Town of Surfside

Champlain Towers South Memorial Project

Addendum No. 2

Bid Questions

PROJECT
**CHAMPLAIN TOWERS
SOUTH MEMORIAL**

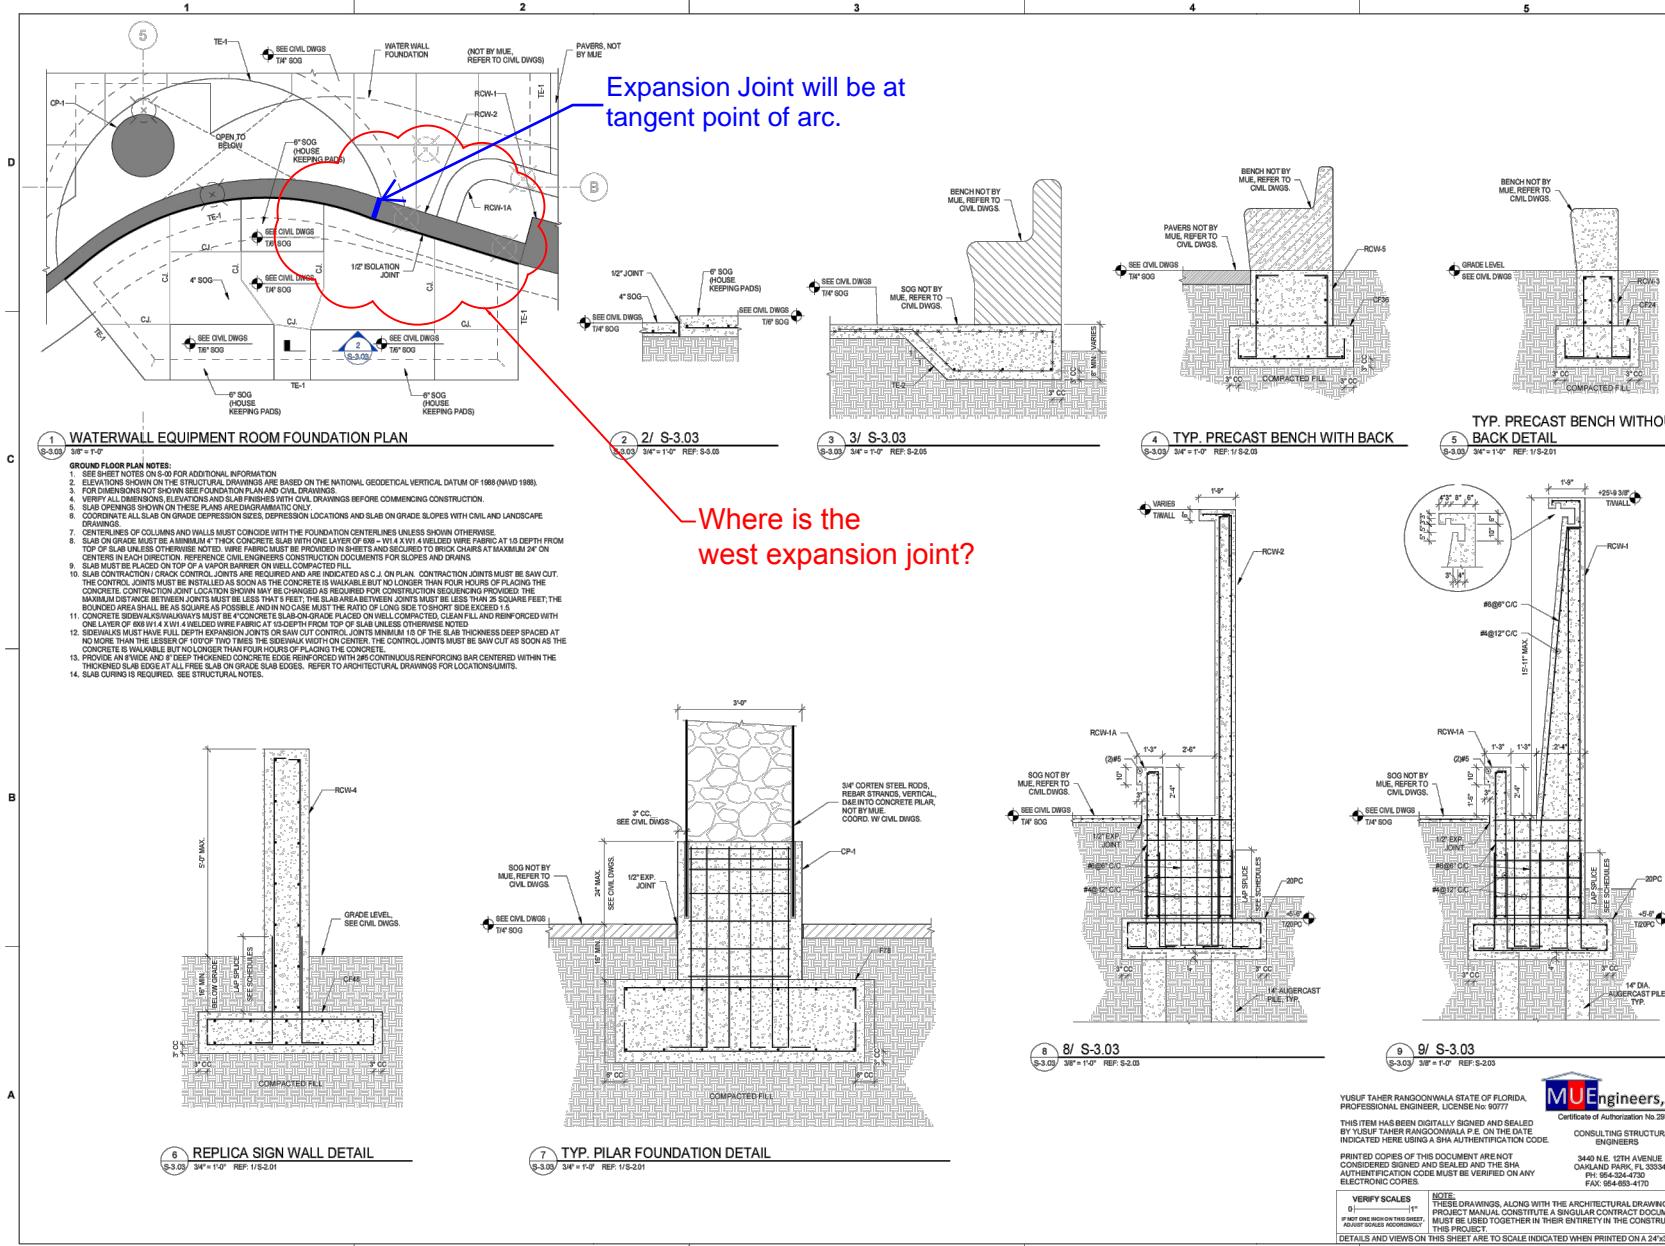
38. Clarify wall sections of the waterwall (RCW-1 and RCW-2) on plans S-3.03 and S-2.10. Plan S-3.03 does not correspond to W01-1.02, which appears to change dimensions and section type.

BidRFI #38

Are these 1'6" (W01-3.00) or—
1'9" (S-3.03)
1'-6" is correct.

- **Wall "cap" should be overall 1'-6" width (inclusive of cap), 8" height per W01-3.00 and 3/LH-504.**

- **Wall "cap" or protruding edges should stop prior to the wall transitioning down - per 1/W01-3.00.**
- **"Normal" wall adjacent to water wall will have a batter (artistic shotcrete topping) that tapers to meet the batter of the water wall. KEITH will coordinate with awarded contractor and provide 3D model as needed to further clarify design intent.**
- **Response noted in blue on RFI plan markup.**

"Normal" wall adjacent to water wall will have a batter (artistic shotcrete topping) that tapers to meet batter of water wall. KEITH will further coordinate with awarded contractor as needed to clarify design intent.
